TRAILS AT ASPEN RIDGE FILING NO.2

EL PASO COUNTY, CO

ROADWAY & STORM IMPROVEMENT PLANS

FEBRUARY, 2020

Know what's below.
Call before you dig.

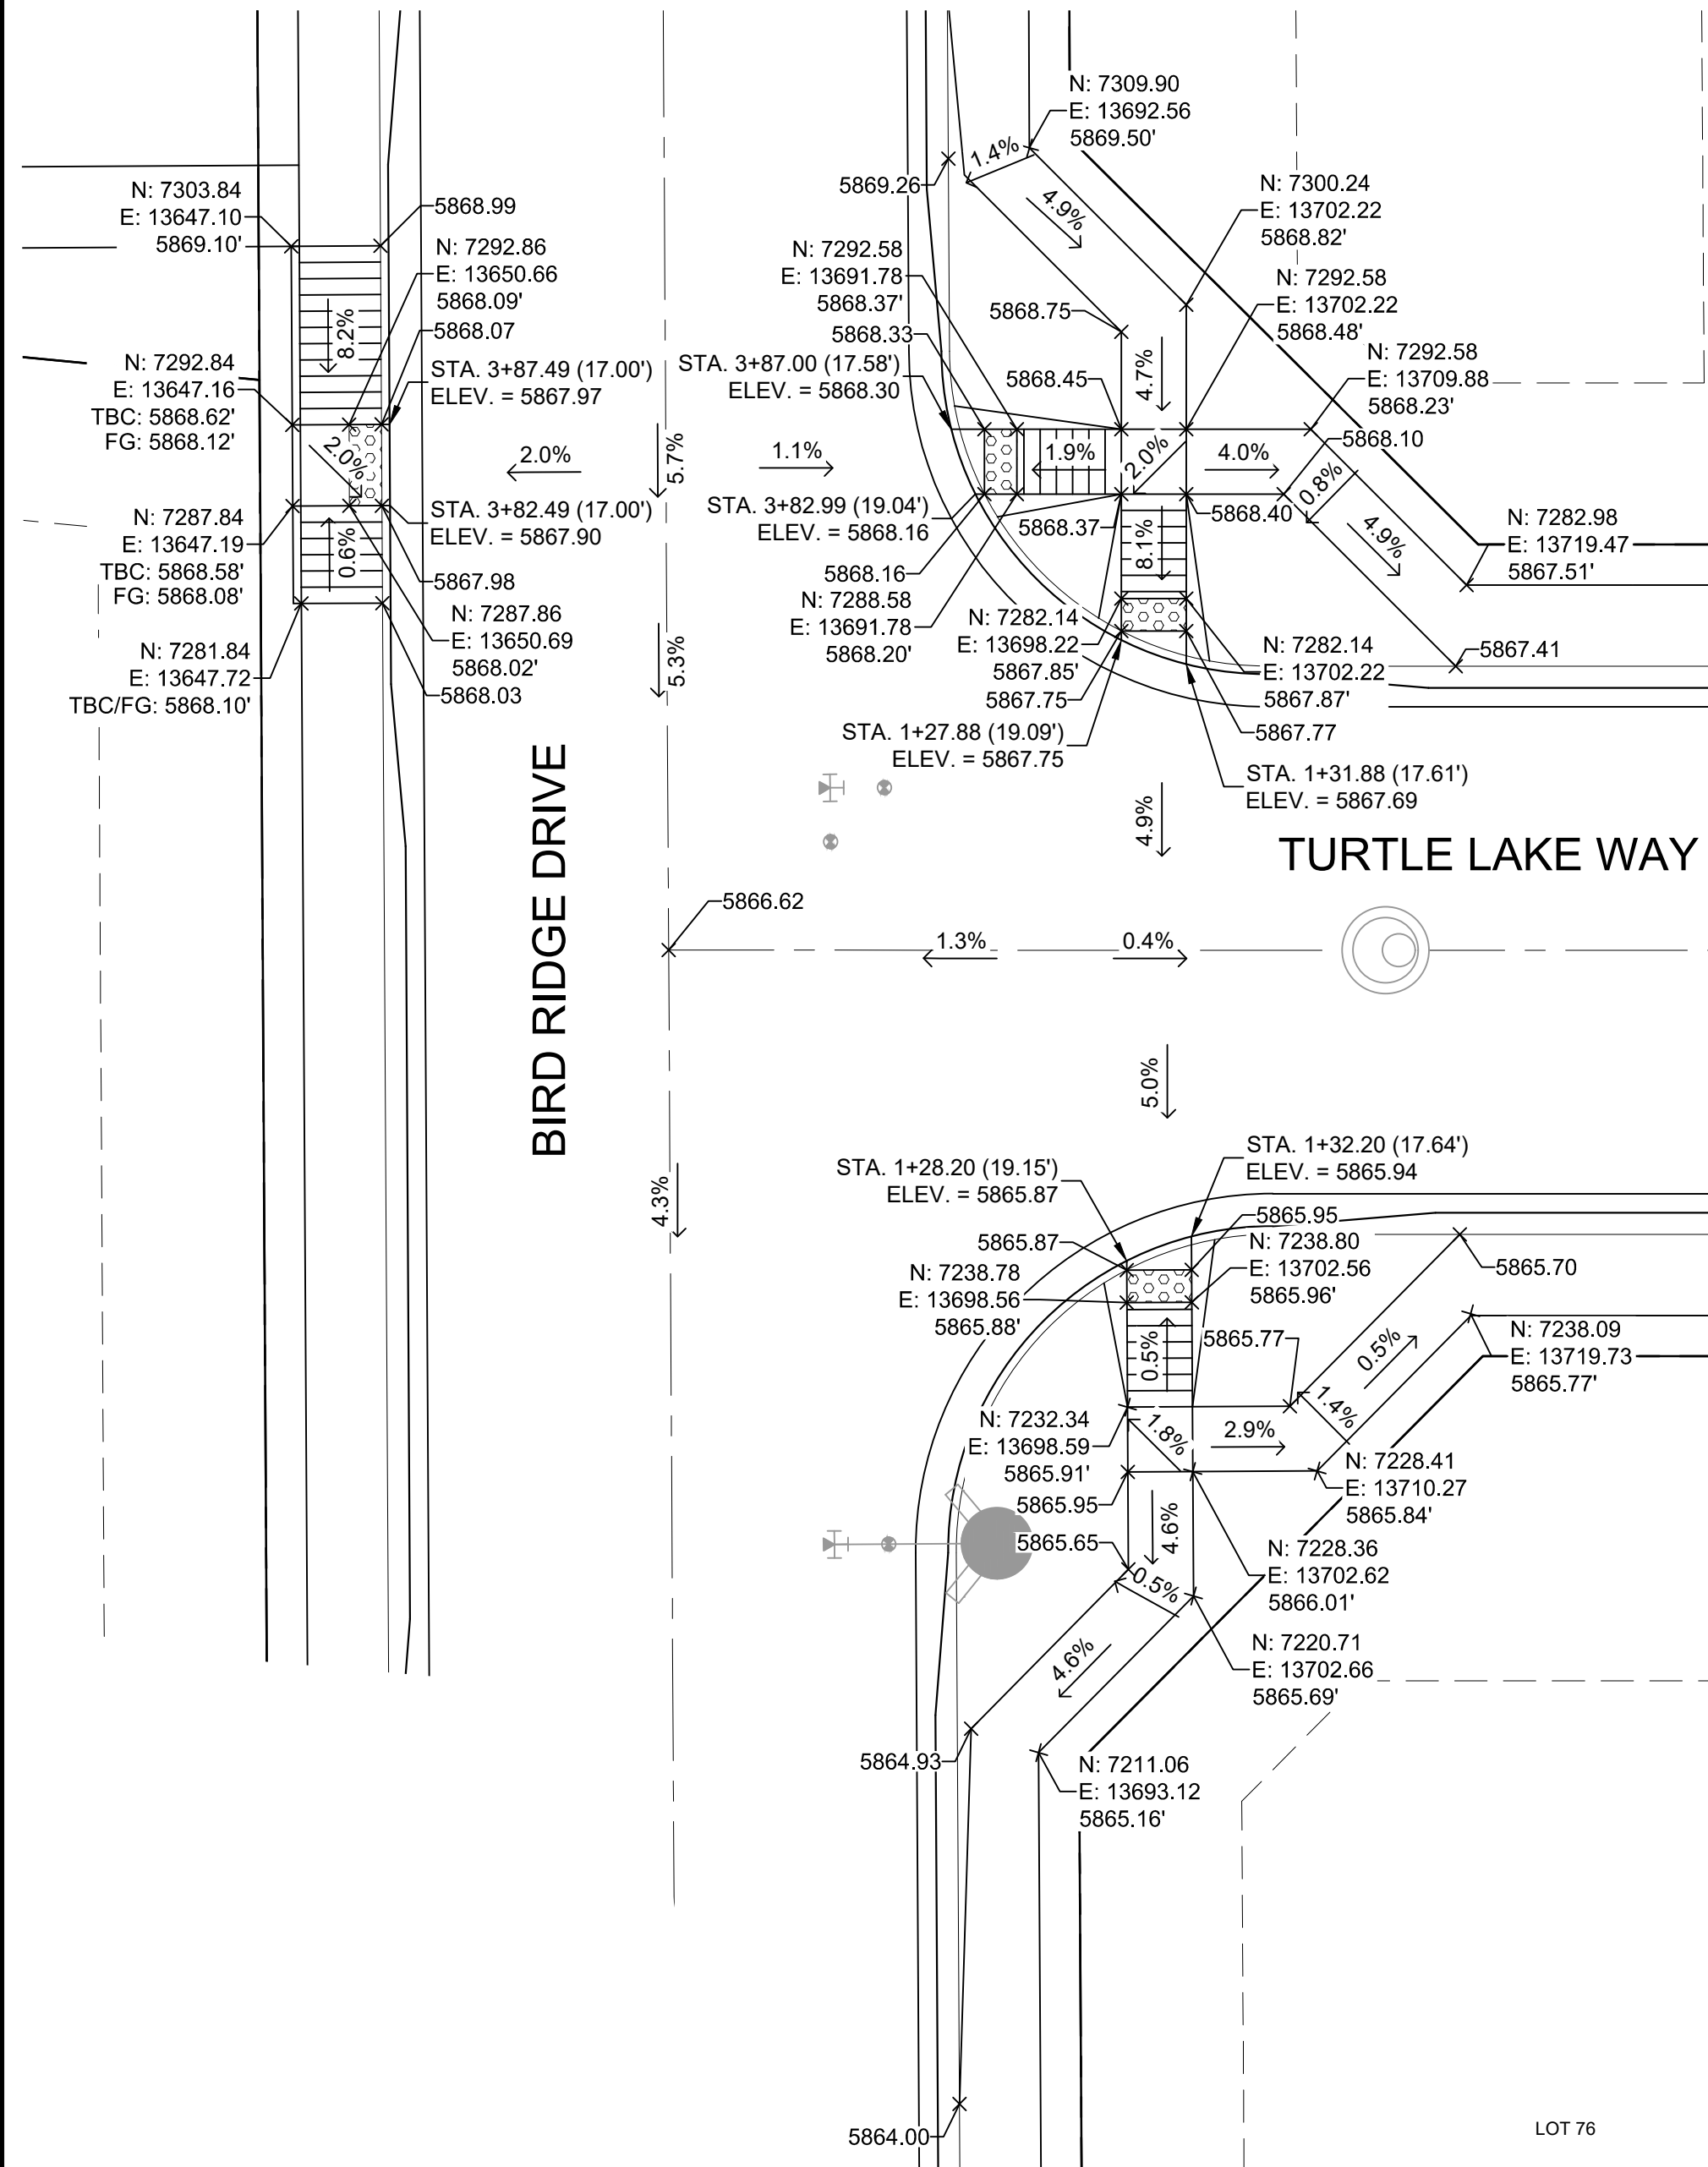
Revise or submit a deviation request. All "T" intersections shall have a minimum of 3 access ramps per ECM 2.5.2.C.

Revise. Missing parallel pedestrian ramp.
